SUBJECT: Beaver Valley Power Station - Unit No. 2
Docket No. 50-412
Response to Draft SER Open Item Nos. 175 and 176

Draft SER Open Item No. 175 (Section 2.5.4.3.3) - Measured, Estimated, and Allowable Settlement Data:

Draft SER Open Item No. 176 (Section 2.5.4.3.3) - Differential Settlements:

FIGURE 2.5.4-20
PREDICTED TOTAL STATIC
SETTLEMENT
BEAVER VALLEY POWER STATION-UNIT 2
FINAL SAFETY ANALYSIS REPORT

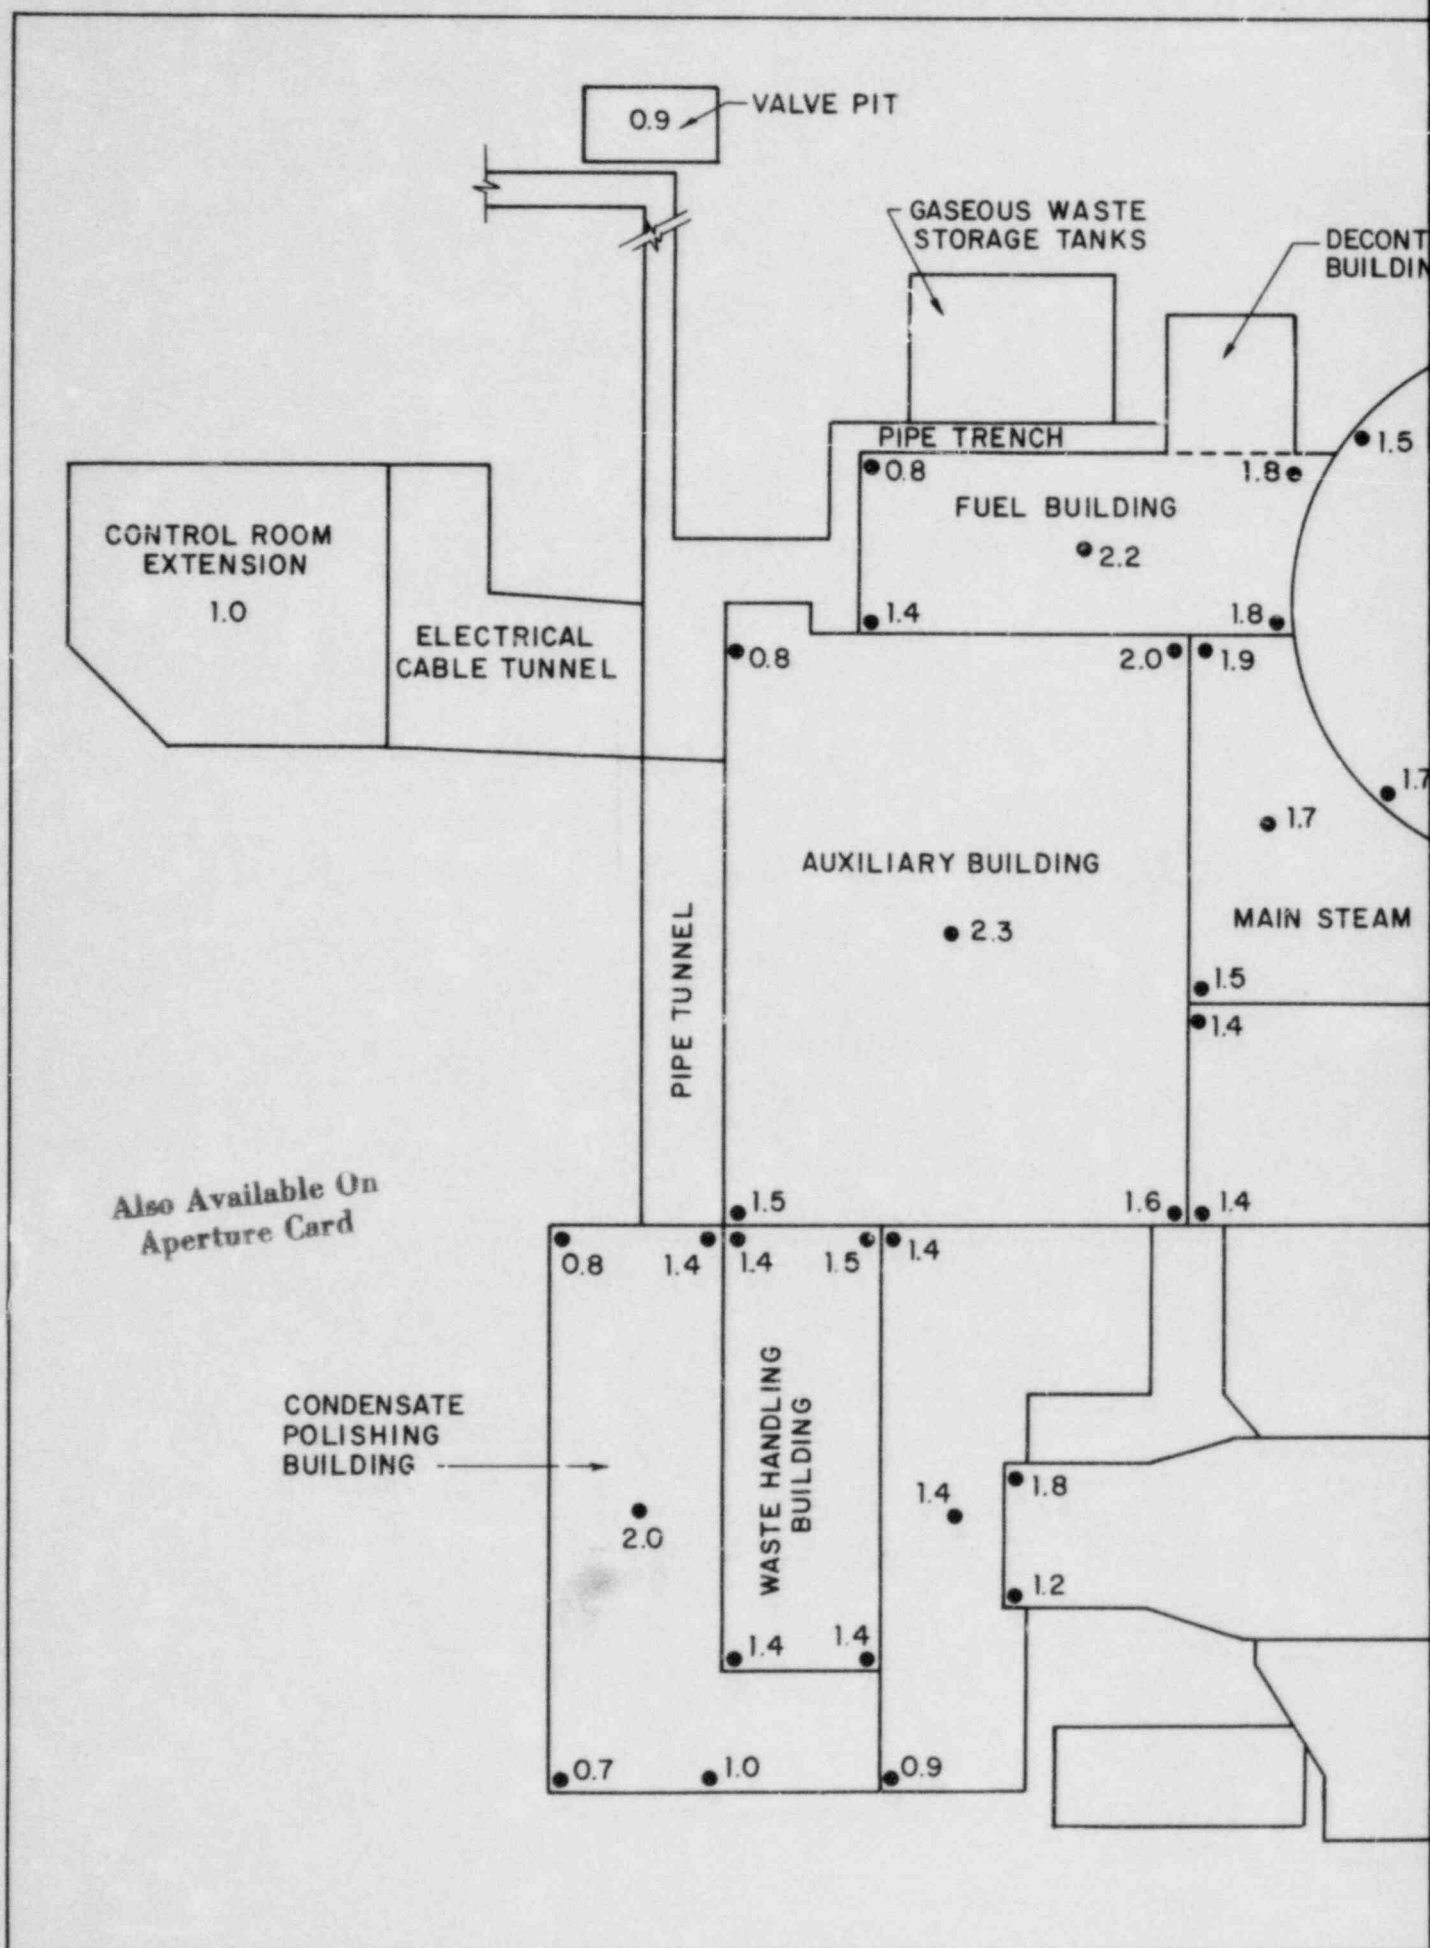
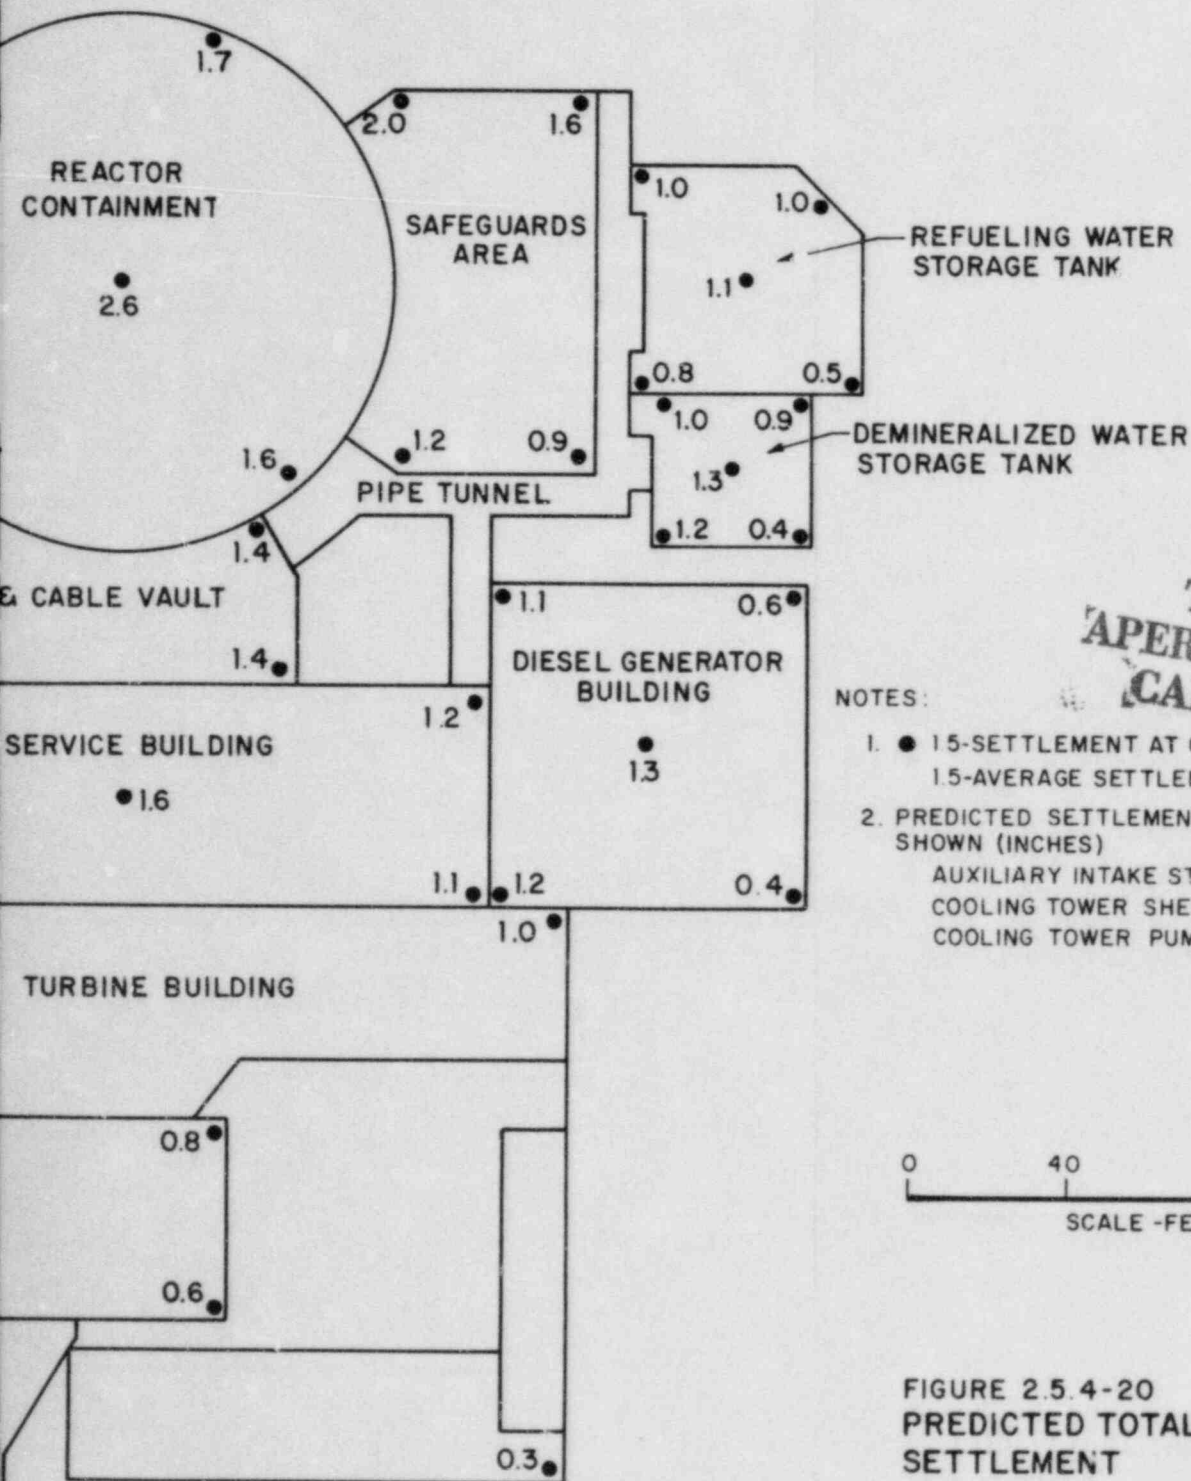
Based on the settlement data given in the FSAR Figures 2.5.4-20, and 2.5.4-46, Table 2.5-2 gives a comparison of the estimated and measured total settlement at the corners of a few Category I structures. This table also gives the percentage of structural loading of these structures as of January 10, 1984, provided by the applicant during the geotechnical audit by the staff in January 1984. The applicant has been requested to docket this data, including a comparison of up-to-date measured settlements with predicted values, in a tabular form in the forthcoming amendment of the FSAR. The applicant needs to provide the total loading including the equipment loading, etc. in addition to civil, steel, and concrete loading.

The applicant must include, in the forthcoming amendment of the FSAR, the following information:

1. Allowable total settlement and tilt of safety related structures.

FSAR Figure 2.5.4-20, Amendment 8 (attached), has been revised to indicate a change to the predicted settlement of the valve pit as a result of an increase in the design load shown in FSAR Table 2.5.4-4, Amendment 6. FSAR Figure 2.5.4-41, Amendment 8 (attached), has been revised to agree with the loads shown in Table 2.5.4-4.

A comparison of measured and predicted settlements of plant structures can be made by comparing FSAR Figures 2.5.4-20 and 2.5.4-46.

Allowable total static settlements of the individual BVPS-2 structures have not been determined. However, a prediction of the static settlement of each structure has been made (FSAR Figure 2.5.4-20) to provide an indication of the behavior of plant structures. An extensive settlement monitoring program has been instituted at BVPS-2 to verify the validity of the predictions. The settlement monitoring data will ultimately be used to reassess the predicted settlements of each structure taking into consideration the trends shown by the measured data at each settlement monitoring point. The individual plant structures are not specifically designed for differential settlement or tilt of the foundation. However, observed settlements are periodically reviewed so that any unusual movements can be evaluated on a case-by-case basis.
